**DOCUMENT 00 90 00
ADDENDUM**

ADDENDUM NO. [3] Date: May 9, 2019

**RE: HOUSING AUTHORITY OF LA CROSSE
2018-19 CAPITAL IMPROVEMENT PROJECTS
1307 BADGER STREET
LA CROSSE, WI 54601
HSR PROJECT NO. 18065**

**FROM: HSR Associates, Inc
100 Milwaukee Street
La Crosse, WI 54603
(608) 784-1830**

E100

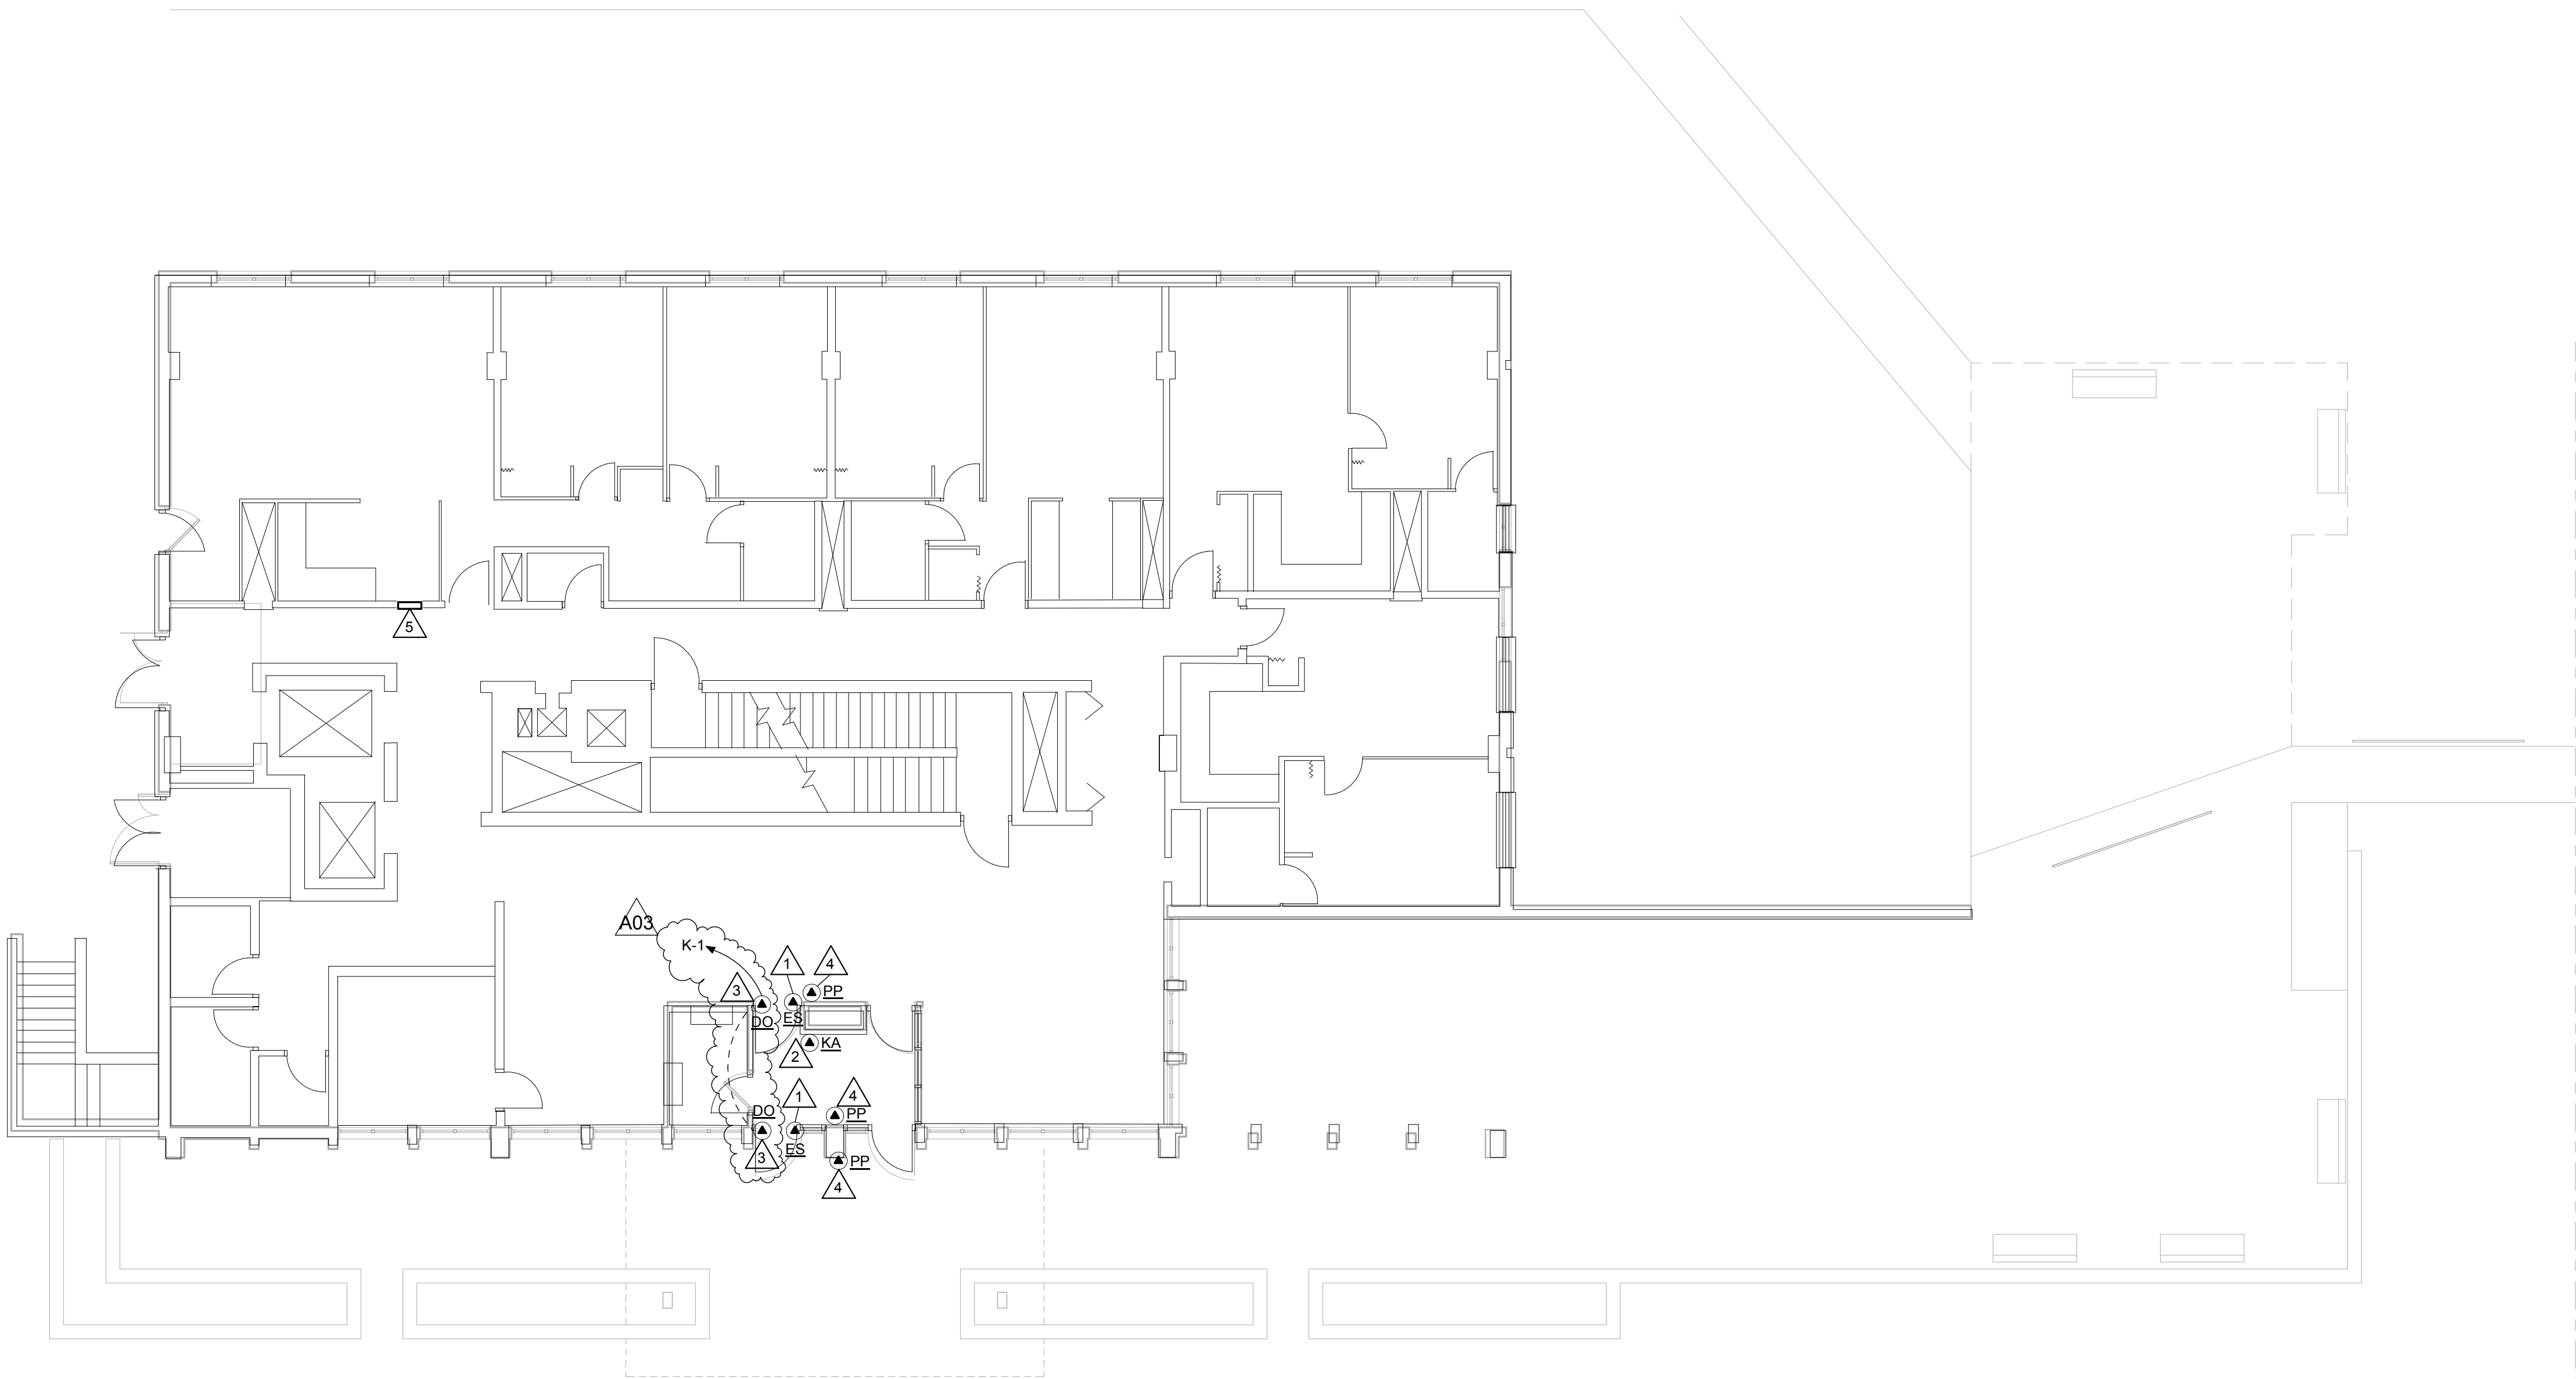
1. Sheet E100 First Floor Electrical Plan (Stoffel Ct) 30 x 42 attached hereto
 - a. E.C to provide 120V power to new door operators.
2. Sheet E200 Electrical Floor Plan (Becker Plaza) 30 x 42 attached hereto
 - a. E.C to provide 120V power to new door operators.
 - b. Existing panel 'D' shall be designated as panel 'G'.
3. Sheet E300 Electrical Floor Plan (Solberg Hts) 30 x 42 attached hereto
 - a. E.C to provide 120V power to new door operators

- 1 PROVIDE CONCEALED CONDUIT RACEWAY UP TO ACCESSIBLE CEILING SPACE FOR ELECTRIC STRIKE. PROVIDE WIRING FROM DOOR OPERATOR. REUSE EXISTING BRANCH CIRCUIT.
2 REPLACE EXISTING KEY ACTUATOR WITH NEW KEY ACTUATOR. PROVIDE WIRING TO NEW DOOR OPERATOR. REUSE EXISTING BRANCH CIRCUIT.
3 PROVIDE 120V POWER TO NEW DOOR OPERATOR.
4 REPLACE EXISTING WIRELESS HANDICAP PUSH PLATE WITH NEW WIRELESS HANDICAP PUSH PLATE.
5 LOCATION OF EXISTING PANEL "K". FLUSH 100A, 208/120V, 3P-4W.
